TVA-SQN-TS-06-04

SEQUOYAH NUCLEAR PLANT (SQN) - UNITS 1 AND 2 - TECHNICAL SPECIFICATIONS (TS) CHANGE 06-04, "MONITORING OF CONTROL OR SHUTDOWN ROD POSITION BY AN ALTERNATE MEANS"

Application of Watts Bar Nuclear Plant (WBN)
Requests for Additional Information (RAIs) from NRC
Regarding Alternate Rod Position Monitoring
to the SQN Technical Specification Change

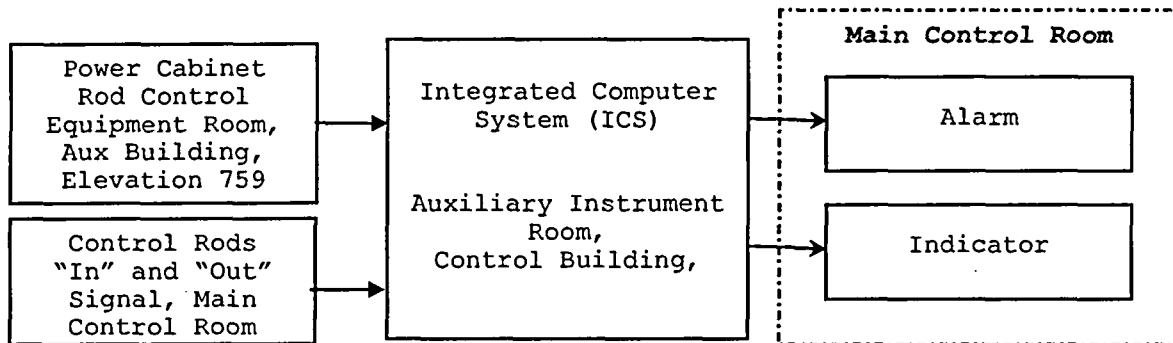
The license amendment request proposes an alternate method to verify rod position when one analog rod position indicator (ARPI) per group is inoperable for one or more groups. The licensee intends to use the voltage of the stationary gripper coil as an alternate means to monitor the rod position of the affected ARPI. The license amendment request does not include a detailed description of the proposed alternate monitoring method and its implementation. The staff requests the licensee to provide:

The alternate means of monitoring the rod control movement consist of monitoring the affected ARPI rod control lift coil current, the stationary gripper coil current, and the rod in and out demands by the plant process computer (ICS). The lift coil current will be monitored at the rod control cabinet using the permanently installed test points that monitor the voltage drop across a metering resistor. In a similar manner, the stationary gripper coil current will also be monitored via test points using another metering resistor. These test points develop a small voltage signal that varies with the current that is supplied to their respective coils. These measurement voltage signals will be routed to the process computer analog inputs using temporary cables between the test points to permanently installed cables that are used during outages for response time testing that run between junction boxes in the rod control room, the auxiliary instrument room, and the computer room. Temporary connections will be made between the computer room cable ends and the computer input/output (I/O). These sample voltages will pass through isolation resistors and the computer input has very high input impedance such that this measurement will not impact the normal operation of rod control.

The "IN" and "OUT" signals are sent to control board lamp indicators in the main control room (MCR) on M-4. These lamp voltages originate in the rod control cabinet and illuminate anytime there is a demand for a rod in or out motion, whether the rod control is in bank select, manual, or automatic rod control. These lamp voltages will be sampled by the computer after passing through isolation resistors by passing through permanently installed junction boxes in the MCR, auxiliary instrument room, and then the computer room. These junction boxes and cables are normally used during plant outages for response time testing and would be available during plant operation for this purpose. Temporary connections will be made in the MCR in the back of M-4 to access the lamp voltages and the junction box near M-4. Temporary connections again will be made in the computer room between the ends of the response time cables and the computer I/O.
